RAI 7

Three Mile Island, Unit 1
 DRAFT RAI Responses Provided in
 Support of Discussions with NRC on Sept. 23, 2009

Figure 11-1: TMI-1 Containment Sump Configuration

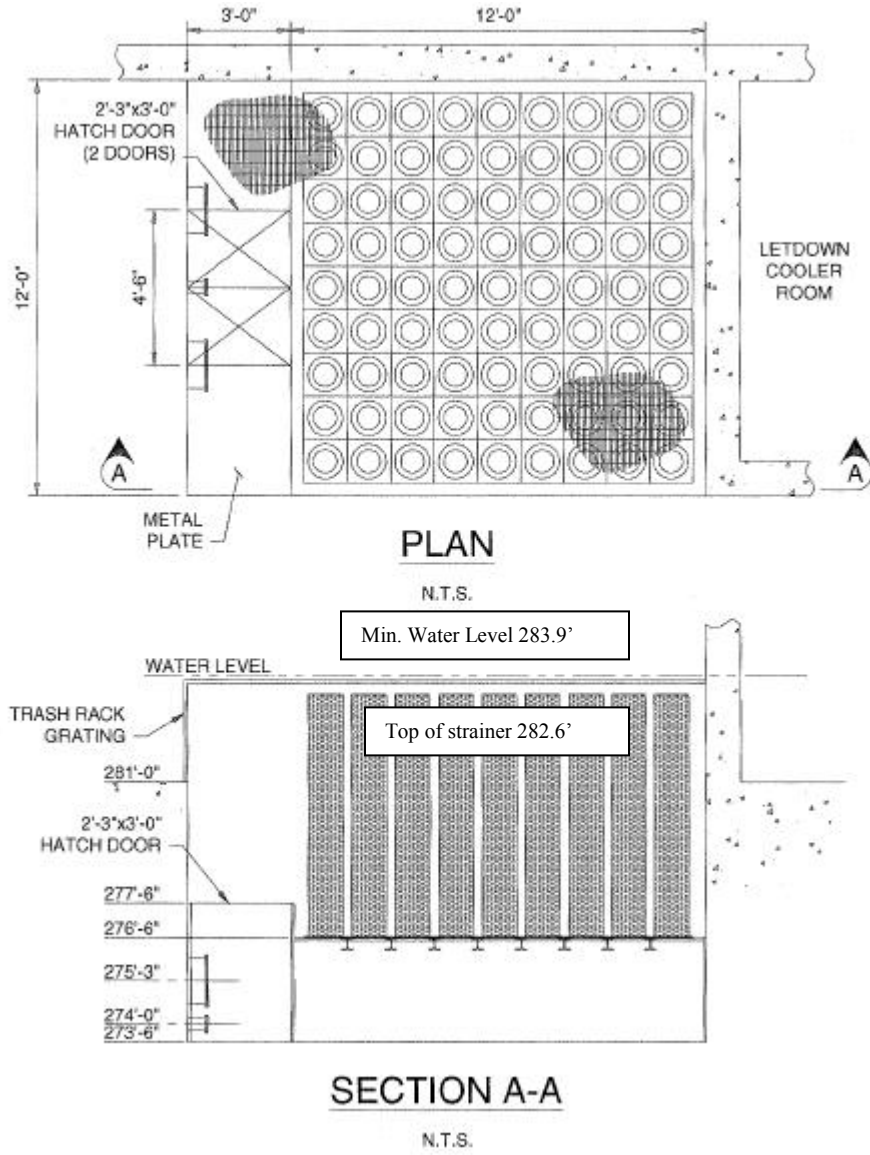
The staff requested additional information on whether containment overpressure was credited for the strainer flashing evaluation. The licensee provided additional information in this area, but it seemed that the question was not understood. The licensee evaluated flashing at the pump suction, but did not address potential flashing in the debris bed or within the strainer. Flashing within the strainer or debris bed can result in additional head losses. The licensee should verify that the potential for flashing at the strainer has been evaluated or provide the parameters such that the staff can verify that flashing will not occur. The minimum margin to flashing at the strainer should be provided. For example, provide strainer submergence, sump temperature, and strainer head loss as a function of time. If required, provide the minimum available containment pressure at the evaluated times.

An illustration of the TMI-1 strainer is provided in Figure 11-1. The minimum water level is at elevation 283.9' and the top of the strainer top hat is at elevation 282.6' which provides approximately 1.3' of submergence to the top of the strainer top hat. As shown in the figure, the Emergency Core Coolant System (ECCS) pump suction inlet centerline is at elevation 275'-3" which provides approximately 8.5' submergence. Given the orientation of the vertical top hat strainer at TMI-1, flashing within the strainer at the debris bed due to potentially minimum submergence would, if it occurred at all, occur at the top of the strainers first. Therefore, the flashing analysis evaluates hydraulic conditions at the upper top hat elevation.

- a) If the submergence is greater than the debris head loss, then the fluid pressure within the debris bed is greater than the fluid pressure at the pool surface (the containment pressure) and clearly no flashing within the debris will occur, or
- b) If the submergence is less than the debris head loss, the potential for flashing within the debris bed does exist. To determine whether or not flashing does actually occur, one must calculate the fluid pressure on the inside of the strainer surface (containment pressure + submergence – debris head loss) and compare this to the fluid vapor pressure. If the vapor pressure is greater than this calculated fluid pressure, flashing would occur without overpressure. If the fluid pressure is greater than the vapor pressure, no flashing occurs.

The preliminary analysis results show that there is no potential for flashing until the pool reaches a temperature of 140 deg F (when chemical effects become significant), as prior to this time the debris head loss is less than the minimum strainer submergence. At temperatures colder than 140 deg F, the maximum head loss is well in excess of the minimum submergence. However, using the formula for fluid pressure noted above, the minimum fluid pressure within the debris bed at the top of strainer is well above the vapor pressure below 140 deg F. Therefore flashing of the fluid at the debris bed will not occur. This analysis does not take into account any containment overpressure (pressure over the initial containment pressure).

Photograph 1 – Settled Debris from TMI-1 Test Conducted 3/07 (southwest corner)

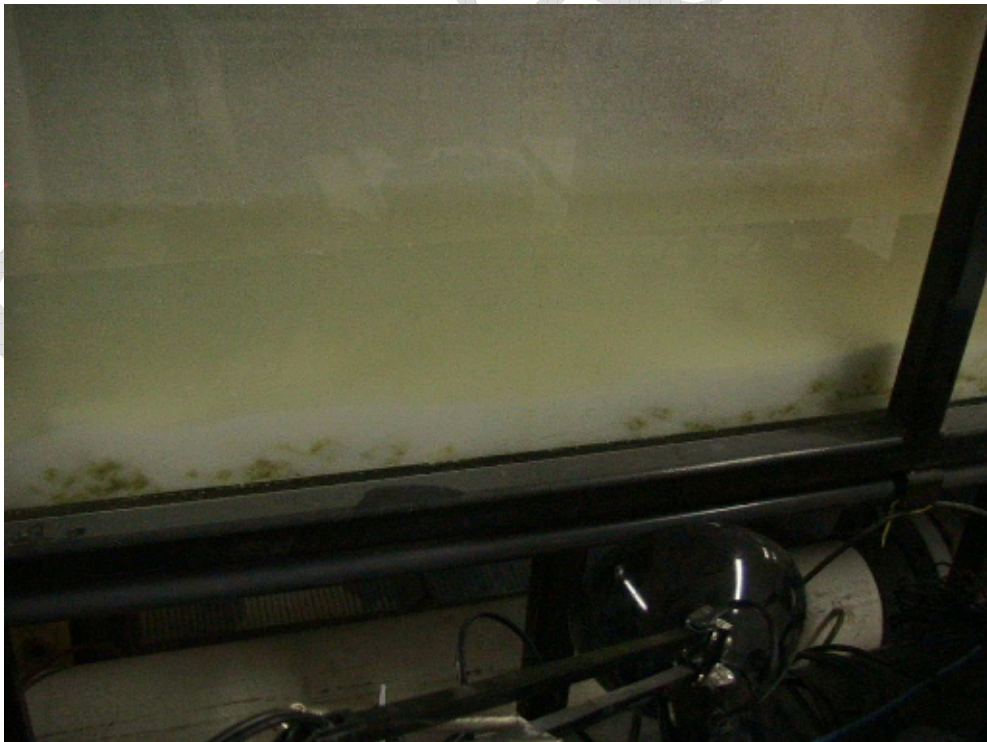
The staff requested justification for why the settlement that occurred during integrated chemical effects testing did not result in non-conservative head loss values. The licensee stated that multiple attempts were made to re-entrain settled debris into the test flume. The staff was present at a test of the TMI-1 strainers. During the test, the staff noted non-prototypical settlement of both chemical and non-chemical debris in the test tank. The trip report reference may be found at ADAMS Accession No. ML071230203. As noted in the trip report, the test tank geometry was significantly less conducive to transport than actual plant conditions. The trip report noted that the effects of debris settling should be addressed during the evaluation of the testing. The licensee should evaluate the effects of the settling on the test results.

The test configuration previously used in Alion Tests employed top hat arrays consisting of 9 total top hats (3 x 3 array). However, in order to accommodate the volume of chemical precipitates introduced to the tank in the March 2007 test, the array size was reduced to utilize a total of 4 top hats (2 x 2 array). This required a lower overall test flow rate to maintain the proper approach velocity at the strainer surface. For the 2 x 2 array, flow was reduced to 44% of the rate associated with the 3 x 3 arrays previously tested. This greatly reduced the effectiveness of the standard diffuser and allowed for the accumulation of settled physical and chemical debris on the floor of the test tank. Manual agitations of the tank were also not effective in suspending the settled debris sufficiently. Photographs 1 and 2 show the settled debris visible in the tank at the end of the March 2007 testing.
